HORSHAM DISTRICT COUNCIL CONSULTATION

TO:	Horsham District Council – Planning Dept
LOCATION:	Land East of 1 To 25 Hayes Lane Slinfold
DESCRIPTION:	Outline application with all matters to be reserved except for access and layout, for the erection of 38no. dwellings, (including 13no. on-site affordable housing units), together with access from Hayes Lane, vehicle and cycle parking, landscaping, open space and play provision, sustainable drainage, and re-alignment of Public Right of Way No.3782
REFERENCE:	DC/25/2006
RECOMMENDATION:	Advice / modification to roadside TPO'ed trees RPA's and modification to new western road alignment is needed to address its location in the RPA of trees T60, T61 and likely T62; Holding objection is currently raised to the scheme on the above grounds
SUMMARY OF COMMENTS & RECOMMENDATION: <p>The submitted Arboricultural Impact Assessment (AIA) is broadly compliant with BS 5837:2012 and generally provides sufficient information to assess the arboricultural constraints of the site. A total of 64 individual trees, along with groups, hedgerows, and scrub, were recorded. The categorisation of trees broadly reflects their observed condition and contribution, wit

Preliminary Drainage Strategy Sheet 1 Drawing No 22-011-007 & and TPP extracts.

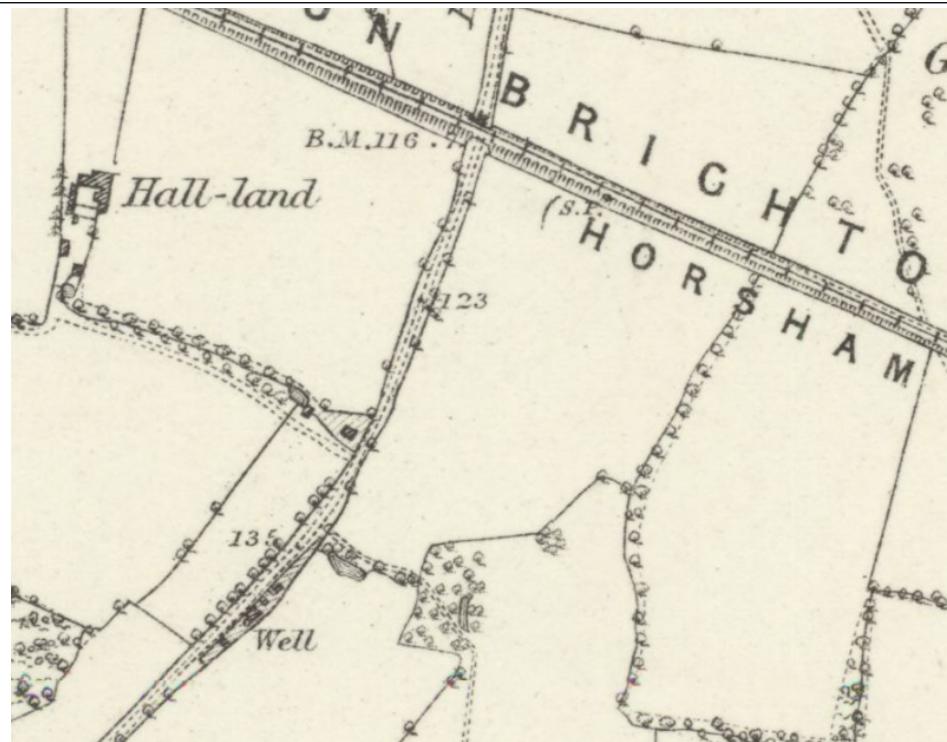
However, there appear to be inconsistencies between the actual number of trees to be removed and the number of trees identified for removal in the Arboricultural Impact Assessment (AIA), particularly when considered alongside the additional plans, such as the Preliminary Drainage Strategy. Specifically, the suds-basin, which appears to be located in the heavily treed area to the east, and its construction would likely require the removal of approximately 11 additional trees, potentially more, depending on the route of the drainage infrastructure, which must connect to the ditch along the eastern boundary.

Therefore, if these trees are to be removed to facilitate the new drainage infrastructure as currently indicated on the plans, they must be accounted for in the calculation of biodiversity net gain and included in the supporting AIA.
